# Abnormal Cruise Control Feel "Rocking Back and Forth" Between 55 - 75 mph

YEAR(S)	MODEL(S)	ADDITIONAL INFORMATION
2016 - 2018	RAV4

May 08, 2017 Rev1:

**Figure 1. Location of Authorized Modifications Label for 2016 – 2018 RAV4**

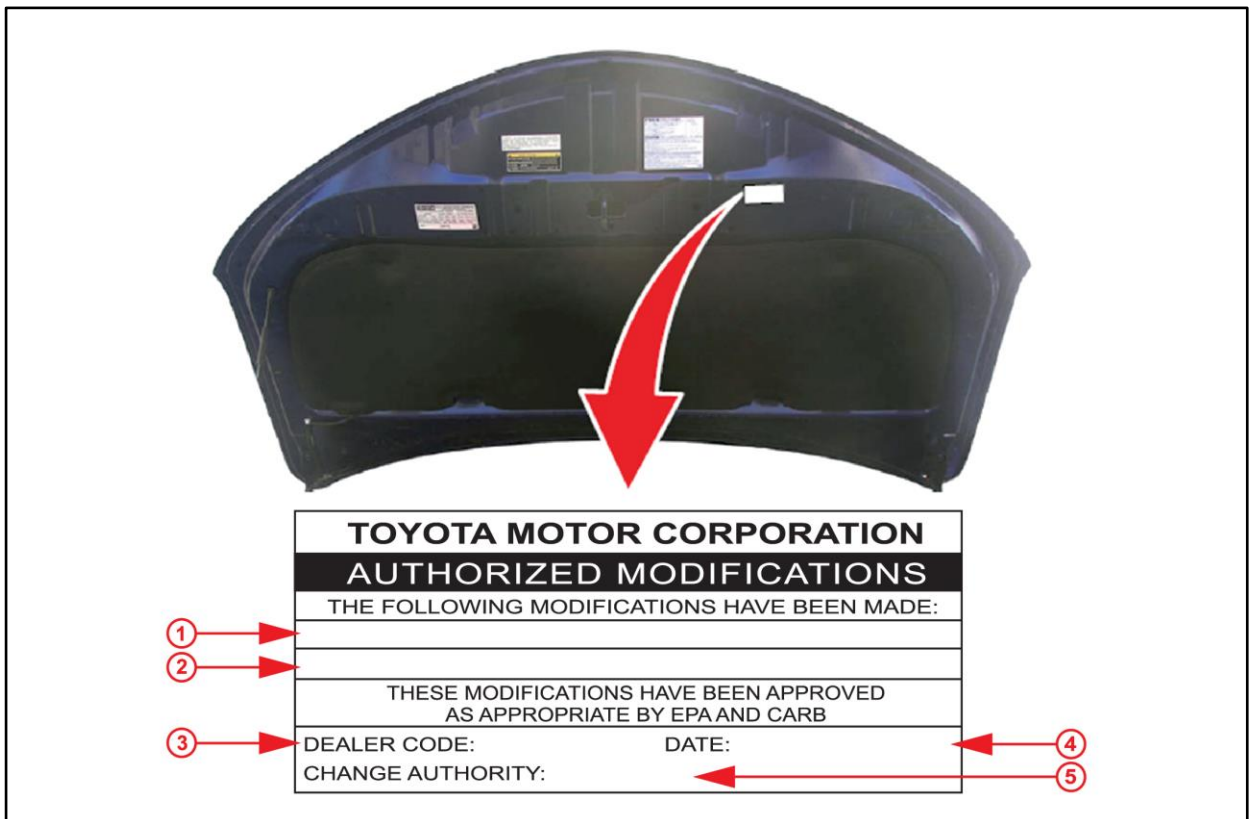
2. Check for the Authorized Modifications Label affixed to the vehicle in the location shown below. Confirm if the ECM (PCM) calibration has been updated.

- Prepare and install the Authorized Modifications Label.
  - Using a permanent marker, enter the following information on the label:
    - ECM part number [Refer to the **Parts Information** section for the **NEW PART NUMBER**]
    - Calibration ID(s) [Refer to the **Calibration Information** section for the **NEW CALIBRATION ID**]
    - Dealer Code
    - Repair Date
    - Change Authority [**This bulletin number**]
  - Install the Authorized Modifications Label to the vehicle at the location shown in Figure 1. The Authorized Modifications Label is available through the MDC, P/N 00451-00001-LBL.
- Verify the rocking condition is no longer present.
